LAND DEPARTMENT.

FILE No. 7 of 1928

PLAN SHOWING PROPOSED BUILDING TO BE BUILT
ON PLOT NO 4 SHEET NO 18, JAIL QUART

Re: Plot No. 4 Sheet J.D-8 Quarter Jail

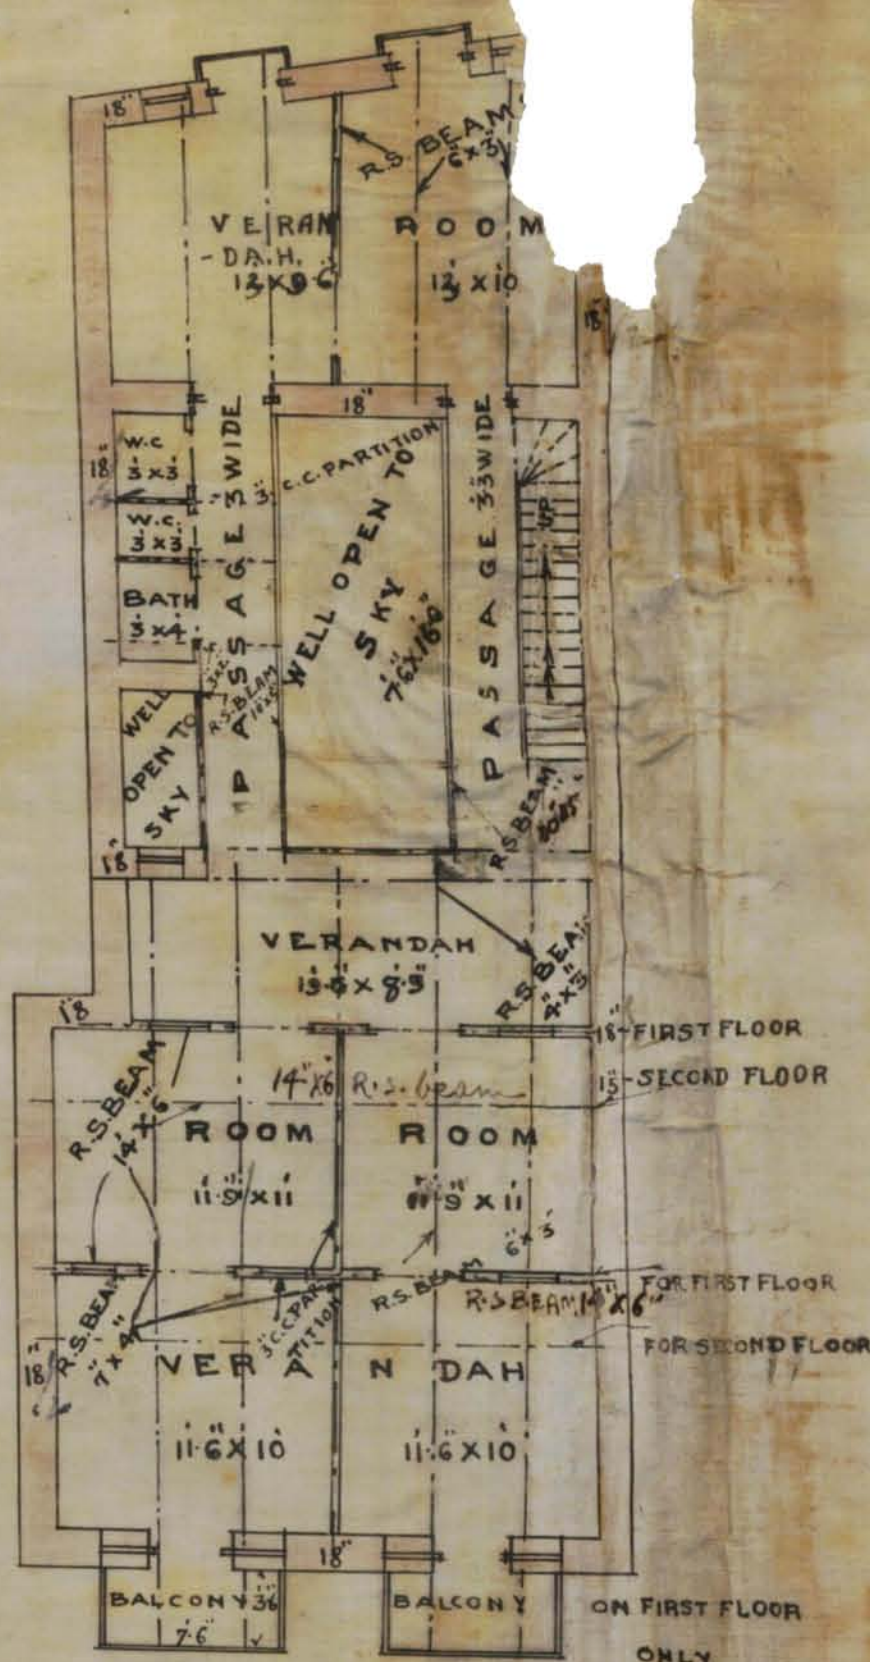
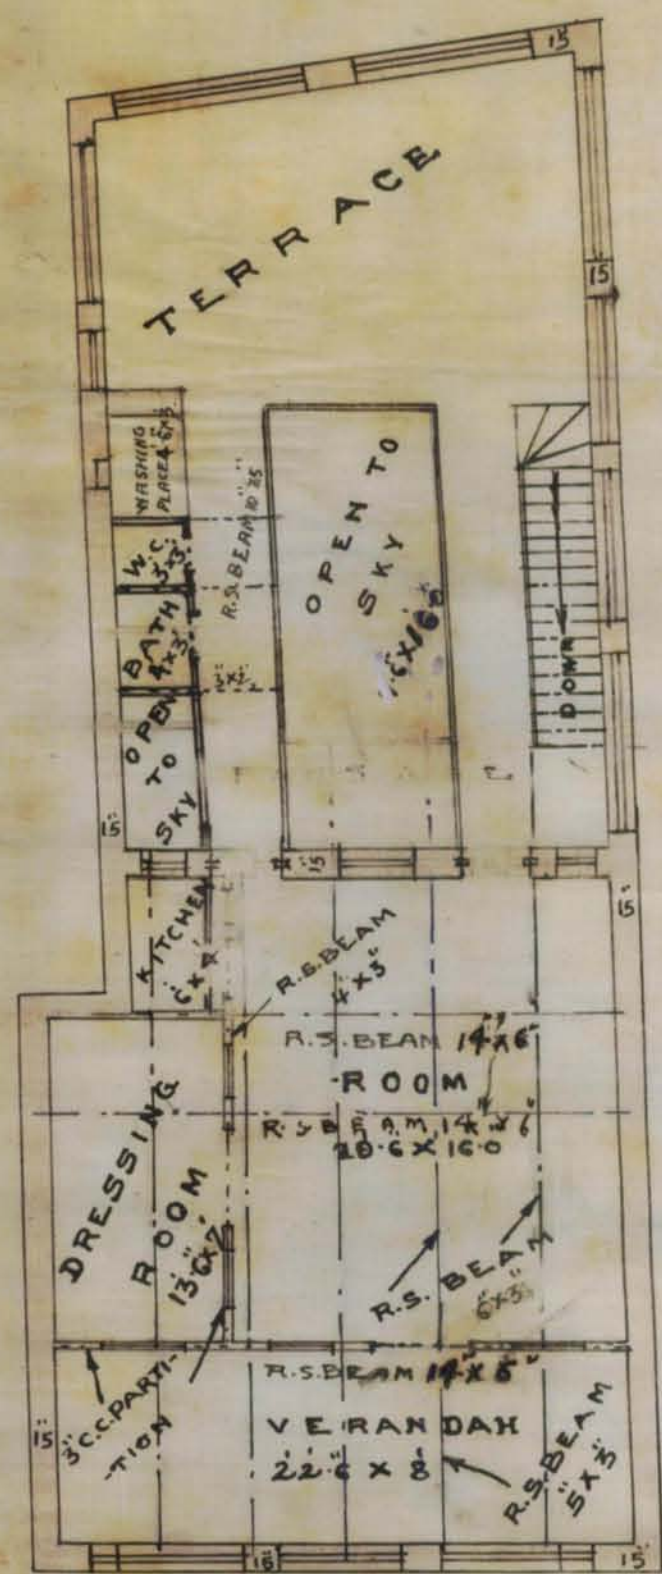
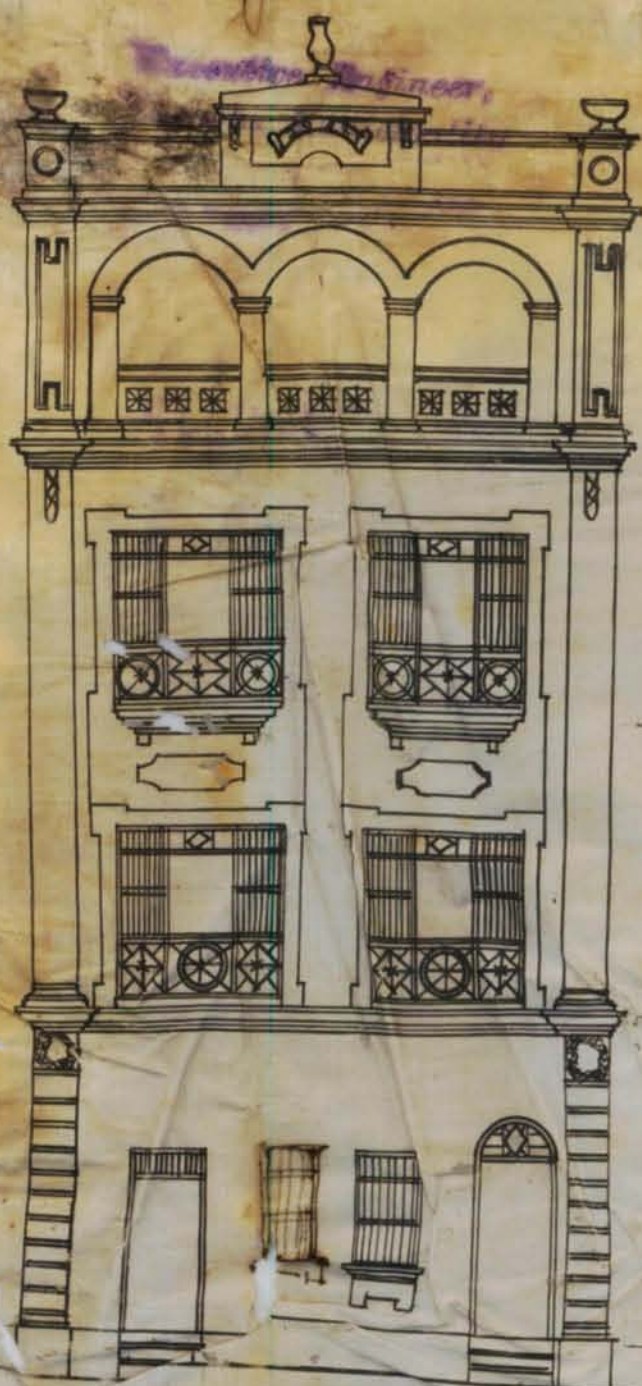
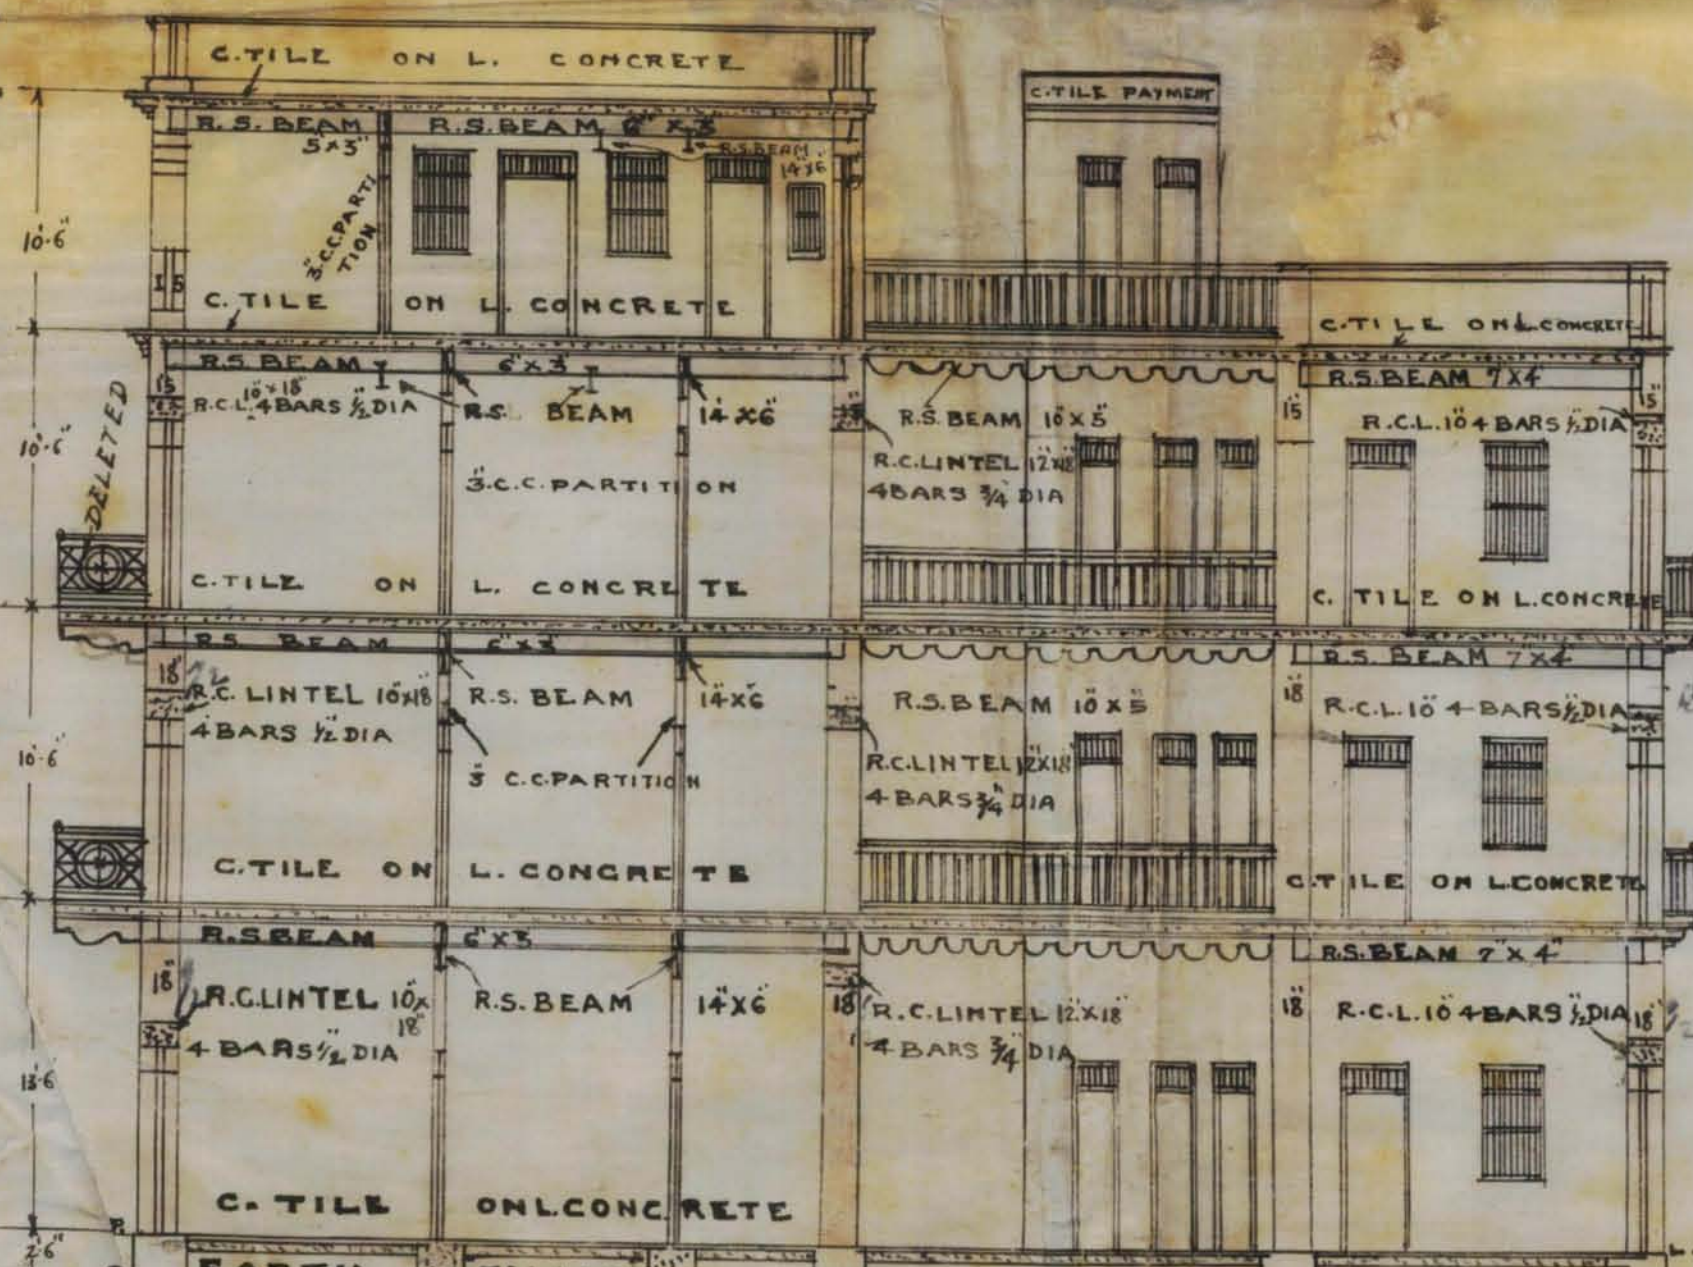
- (1) Kitchens and additional bath rooms are necessary
- (2) Entrance passage should be made 6 feet
- (3) Width of staircase should be shown on plan
- (4) Door A must be closed and window W must be provided
- (5) How will wall C be carried
- (6) For 18' span 9"x4" beam would not do; 12"x5" beam is required
- (7) Balcony must be removed
- (8) Ground floor front verandah must be similar to the upper floor verandah
- (9)

- (1) Kitchen & additional bath room provided.
- (2) Entrance passage is made 5'0" wide.
- (3) Width of staircase is shown on plan.
- (4) Door ~~A~~ is closed & window ~~W~~ is opened on 2nd floor.
- (5) Wall C is to be carried on lintel which is supported by pillars below it.
- (6) For 16' span beam beam 15" x 9" x 4' are suffi-
cient.
- (7) Balcony D is deleted.
- (8) Ground floor front Verandah is shown similar
to upper floor Front Verandah.

PLAN SHOWING PROPOSED BUILDING
TO BE BUILT ON PLOT NO 4
SHEET NO J.L.8.JAIL QUART

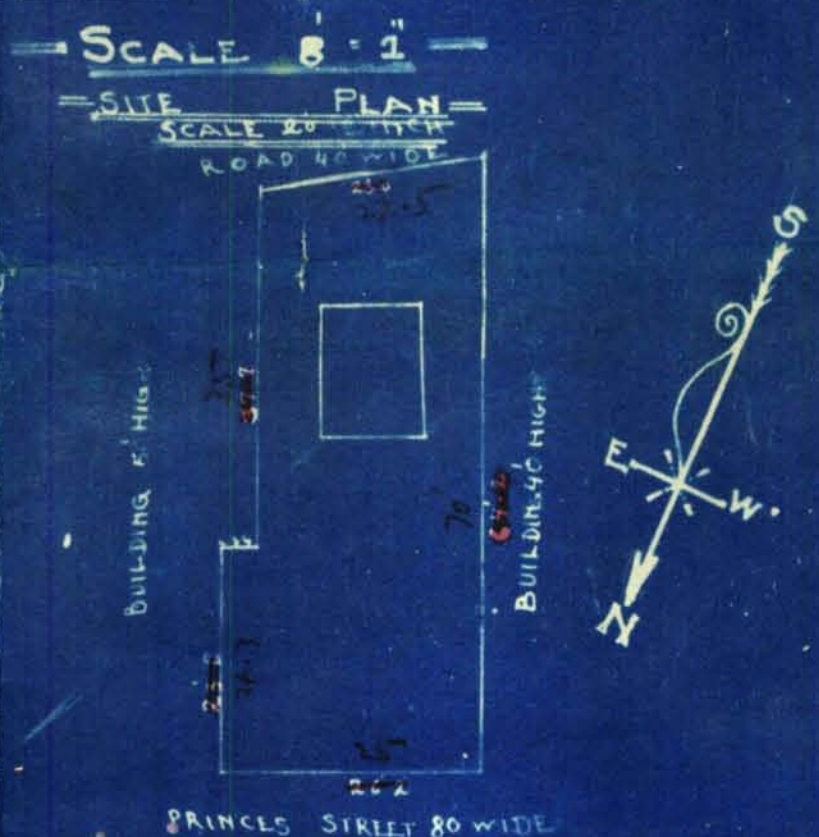
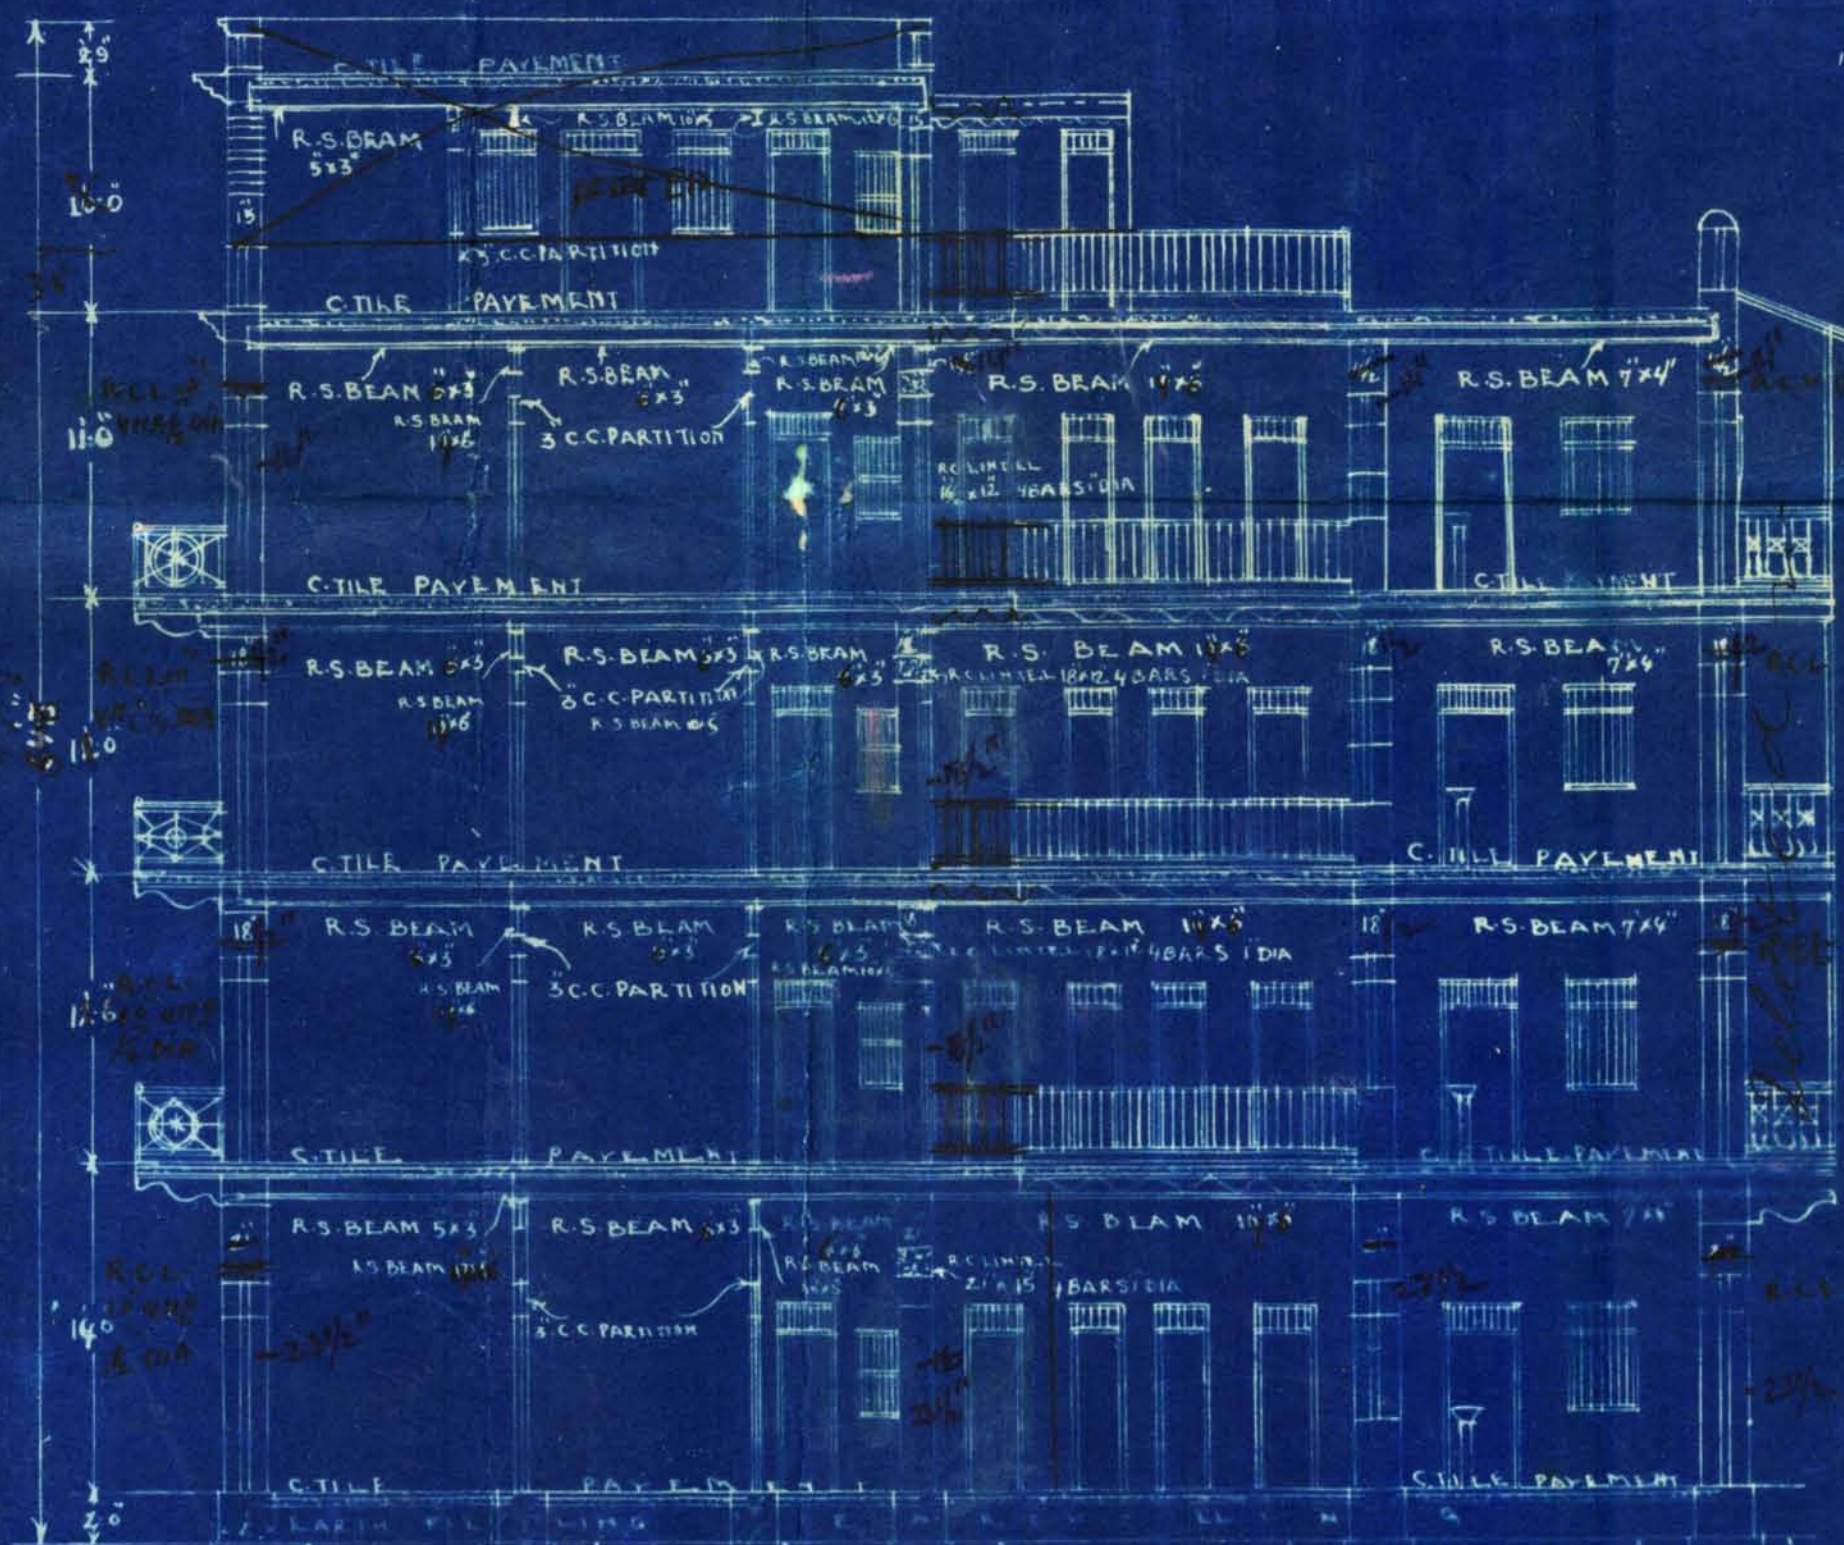
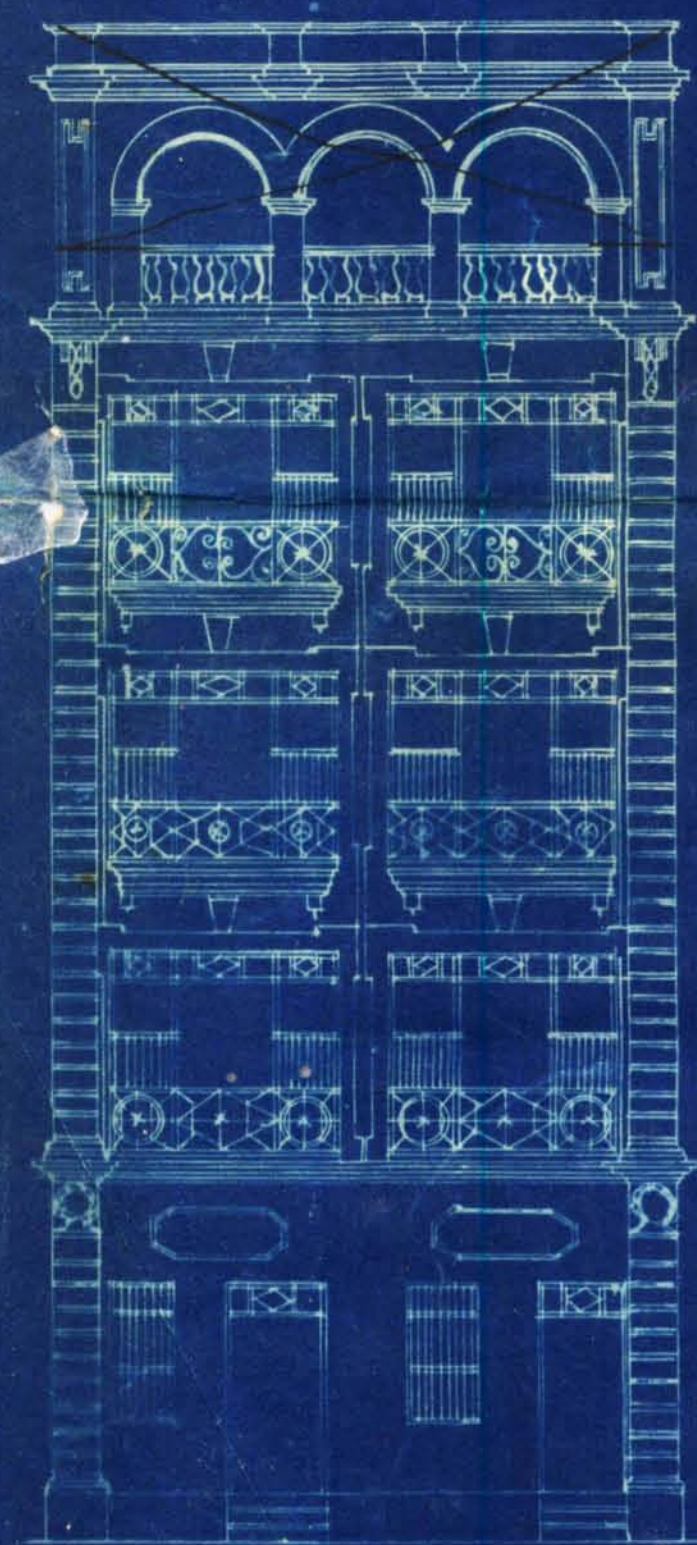
✓ (1) Plans must be neatly drawn.

✓ (2) Recesses in walls cannot be allowed more than half the elevating wall.

✓ (3) Free balconies can be allowed on 1st floor only for the upper floor balcony projection will have to be made paid. Balconies cannot be permitted on 40' road.

✓ (4) Open space dimensions are incorrect.

- (1) Plan is drawn again as required.
- (2) Recesses in walls are made less than half the elevation of the walls.
- (3) The Balcony on the second floor is deleted & that on the 40' wide road is dropped.
- (4) open space dimensions are corrected.
